From: Vito Trupiano [mailto:VTrupiano@doucetengineers.com]
Sent: Tuesday, July 21, 2015 10:06 AM
To: Leslie M. Langford
Cc: Vince Musat; Travis D. Askey; Lindsey A. Oskoui; Melony May
Subject: MPN #14-156-PP - Falconhead West at Vail Divide Preliminary Plat Comments - TxDOT Driveway Application had been Granted

Applicant's Analysis of Driveway Locations

Existing, Planned, and Proposed Driveway Locations

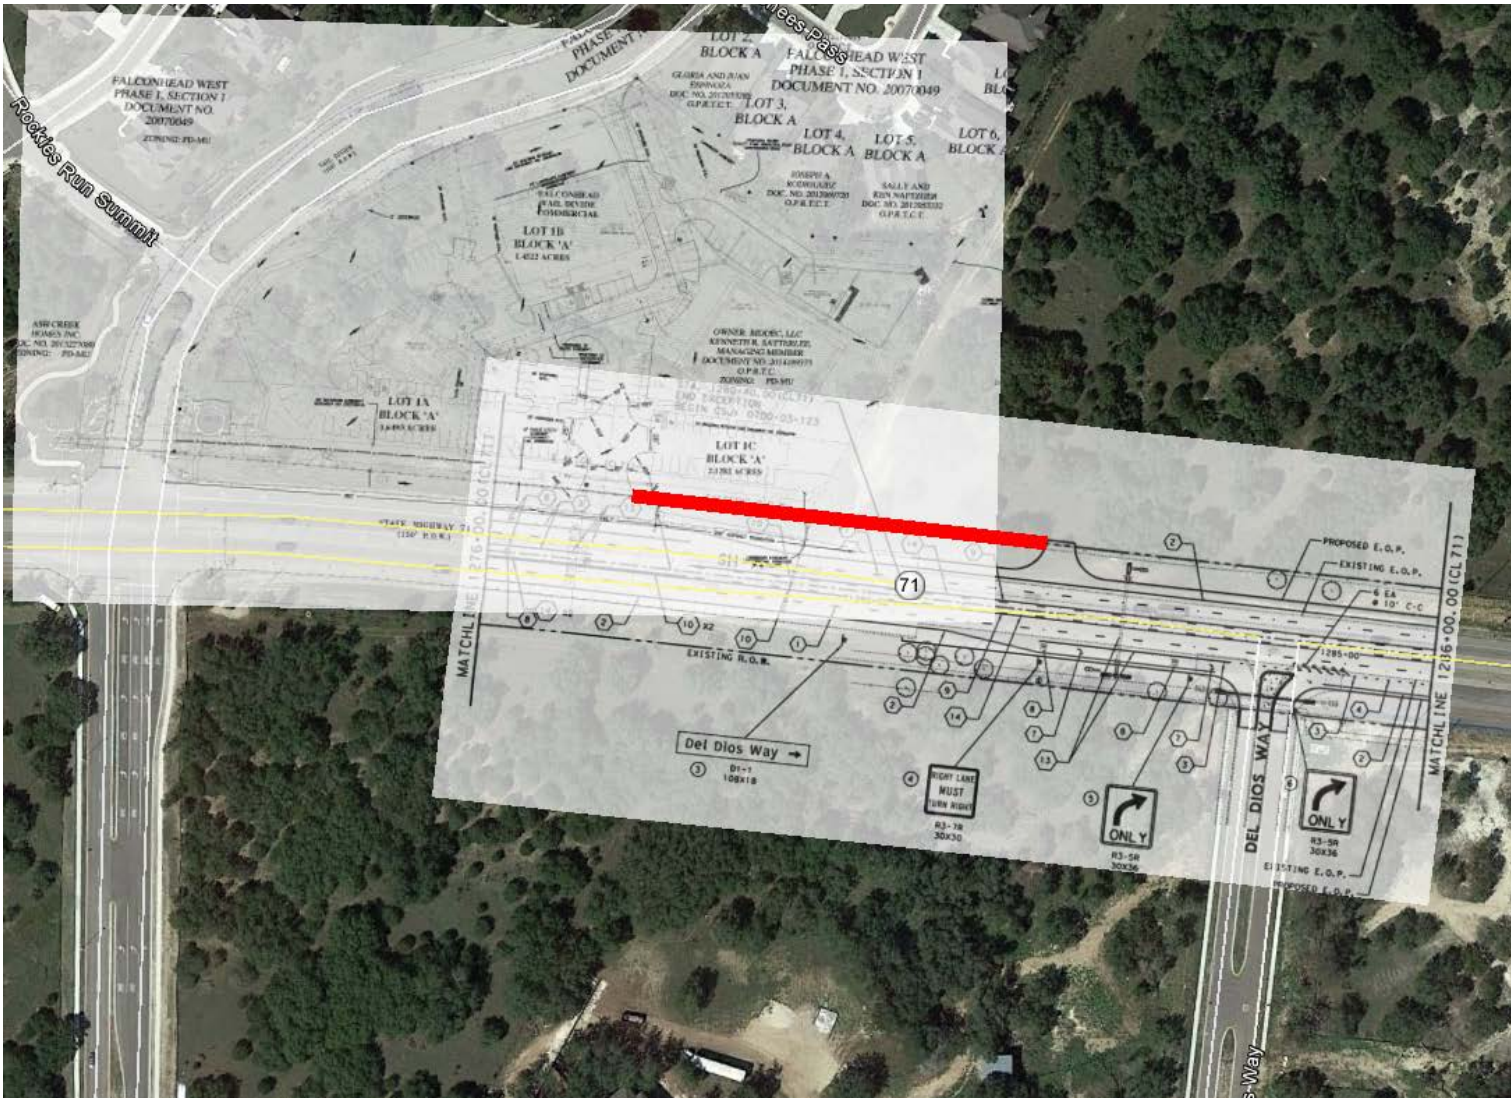
→ 16. **Hwy 71 Access:** At the 11/20/2014 meeting between staff members and the applicant, installing a curb cut on Hwy 71 was discussed, but is not shown on the plat. Please explain your reasoning for not including an access point off Hwy 71 to the site.

- **05/07/15 Staff Response:** Please analyze the existing driveway east of the site as a joint driveway that could be shared with the adjacent landowner. If you have additional questions, please contact James Schwerdtfeger. As a reminder James issued comments on 01/30/2015, and we are awaiting a response on those. Please reflect this analysis in the TIA response to your 01/30/2015 TIA comments.

- **07/06/2015 Staff Response:** Until the TIA comments are resolved this item will not be placed on a Planning and Zoning Commission and/or City Council Agenda. Furthermore, staff will expect the TIA to include an analysis of both driveway locations (the driveway on the eastern edge of the site, as previously discussed, and the driveway currently proposed) in terms of safety, site constraints, etc.

D&A Response: *The Traffic Impact Analysis report, which is being produced by Alliance Transportation Group (ATG), has been updated to include the proposed driveway. ATG has provided, herein, a response regarding the two driveway options on SH 71. Also, the TIA comment response letter to the January 30, 2015 comments issued by R-K Traffic Engineering have been attached.*

ATG Response: *Responses to TIA comments dated 1/30/2015 are attached. The proposed driveway and existing driveway immediately east of the site were reviewed in context with driveway spacing requirements and the TxDOT plans for the improvements to SH 71. Based on the driveway spacing criteria, only one driveway will be permitted for the property directly across from Del Dios Way (Bee Cave 71A LLC) between the Summit 56 development and the Vail Divide at Falconhead development. That driveway cannot be any farther east than Del Dios Way due to the location of the western driveway for Summit 56 Lot 1 which is existing and shown in the TxDOT plans as "Driveway 5". Furthermore, the TxDOT plans already include a driveway ("Driveway 3") for the Bee Cave 71A property approximately 175 feet west of the intersection of Del Dios Way with SH 71. This location is east of the taper for the westbound right turn lane onto Vail Divide and at a location where TxDOT would potentially allow full access (left and right turns) to the property to and from SH 71. The driveway adjacent to the Vail Divide at Falconhead development is in the taper for the right turn lane and would not be allowed full access. Finally, the proposed driveway location for Vail Divide at Falconhead is approximately 435 feet west of "Driveway 3" which exceeds the minimum spacing of 425 feet. The figure below provides aerial imagery with overlays of the site plan for Summit 56 Lot 1 to the east, TxDOT design plans from east of Del Dios Way to east of Vail Divide, the site plan for Vail Divide at Falconhead with the proposed driveway location, and the referenced distance of 435 feet between the driveways shown in red. Selected pages from the TxDOT plans for SH 71 improvements have also been attached to this comment response letter.*
